Subject: Manufactured truss layout sheet 1, dated October 1, 2018 and structural calculations for manufactured trusses, dated October 1, 2018, all by Truss Engineering, Inc.

PUER18-445 PC1

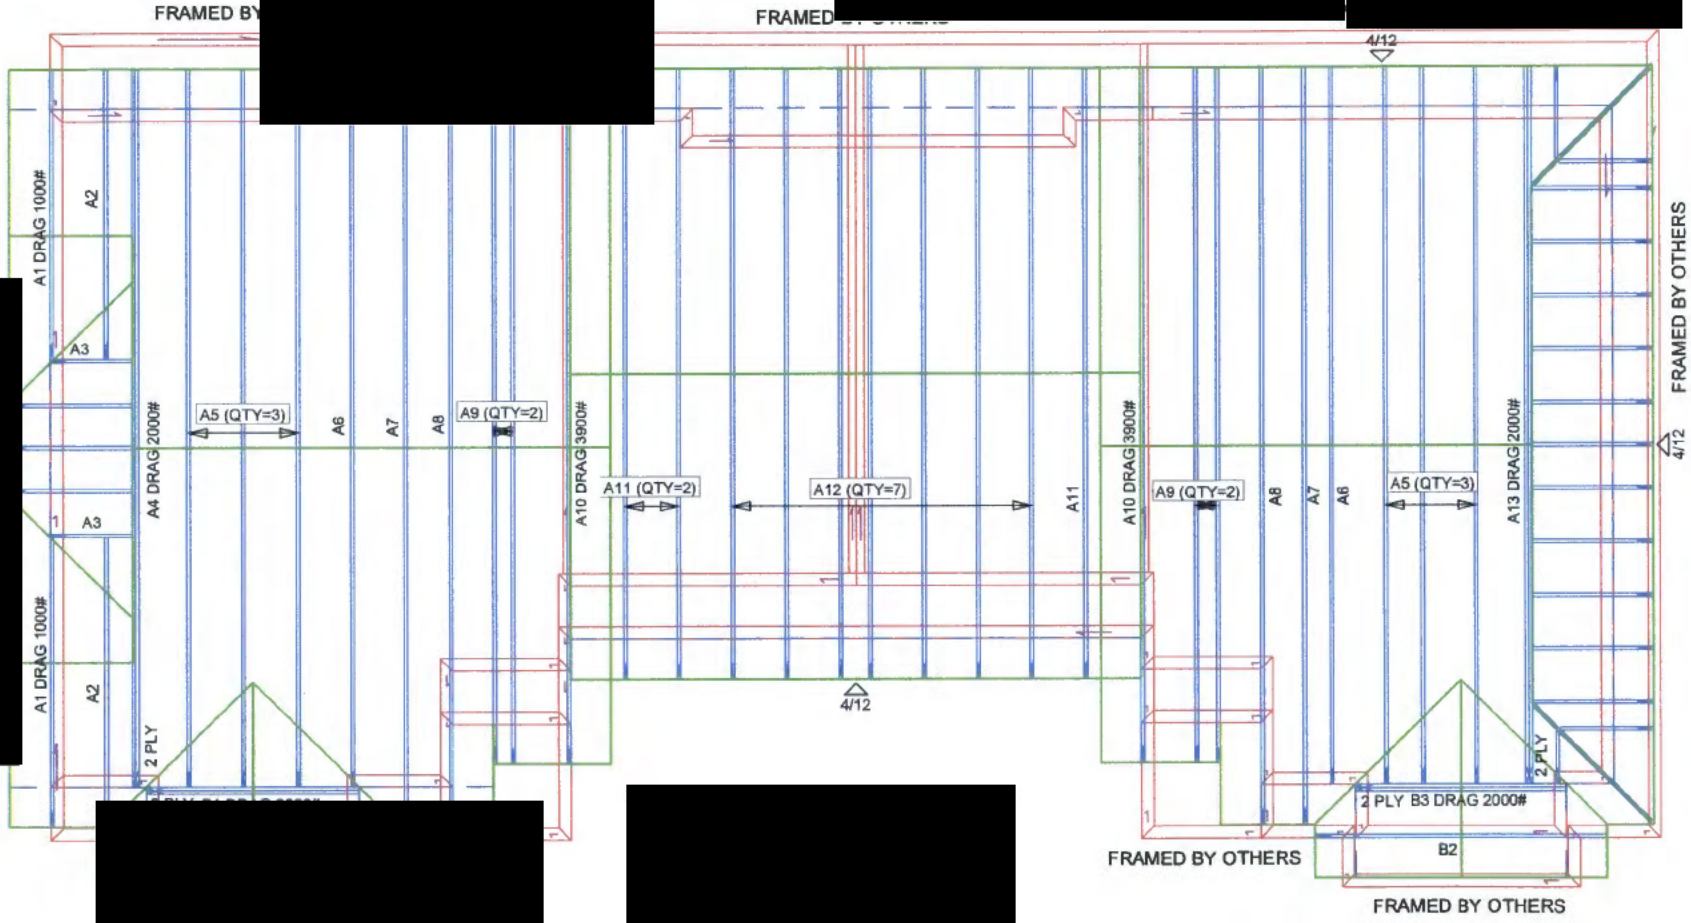
Note:
 Structural EOR review letter attached. Trusses are listed on the cover sheet as a deferred approval item. These are to be submitted to the City for review and approval prior to fabrication.
